Access Compliance Report

Public Rights-of-Way

Intersection ID: 25072	Main Street: CARRIAGE_LAKE_DR	Cross Street: COPPER_RIDGE_TL	Location: SW
ADA ID: C2B9D1B632AA	Ramp Type: Perp	Initial Pass/Fail: Fail	Overall Compliance: No
Severity Score: 37.5			
Codes/Mitigation Info/Possible Solution		Field Measurements/Component Compliance

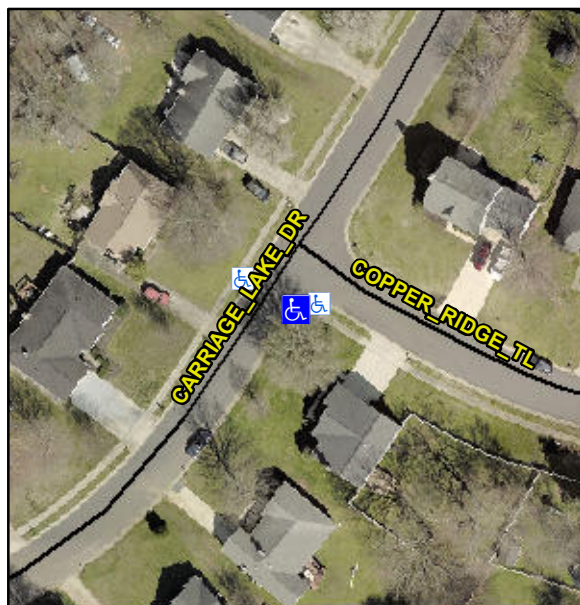
R304.2.2, R304.5.3

Compliance	Description	Data	Compliance	Description	Data
N/A	Ramp Length (in)	89.0	No	Ramp Slope (%)	8.9
Yes	Ramp Width (in)	48.0	No	Ramp XSlope (%)	9.0
N/A	Flare Type LT	N/A	N/A	Flare Type RT	N/A
N/A	Flare Slope LT (%)	N/A	N/A	Flare Slope RT (%)	N/A
N/A	Flare Traversable LT?	N/A	N/A	Flare Traversable RT?	N/A
N/A	Landing Length (in)	N/A	N/A	DWS Provided?	N/A
N/A	Landing Width (in)	N/A	N/A	DWS Contrast?	N/A
N/A	Landing Slope (%)	N/A	N/A	DWS Length (in)	N/A
N/A	Landing X Slope (%)	N/A	N/A	DWS Full Width?	N/A
N/A	Landing Curb? (Y/N)	N/A	N/A	DWS Offset (in)	N/A
N/A	Shared Landing?	N/A			
N/A	Gutter Ponding?	N/A	N/A	Gutter Slope (%)	N/A
N/A	Gutter Lip Ht (in)	N/A	N/A	Gutter X Slope (%)	N/A
N/A	Painted X Walk1?	No	N/A	Painted X Walk2?	N/A
	X Walk 1 Direction	To NW		X Walk 2 Direction	N/A
N/A	X Walk 1 Width (in)	N/A	N/A	X Walk 2 Width (in)	N/A
	X Walk 1 Slope (%)	4.0		X Walk 2 Slope (%)	N/A
	X Walk 1 X Slope (%)	6.8		X Walk 2 X Slope (%)	N/A

Remove & Replace Entire Ramp.
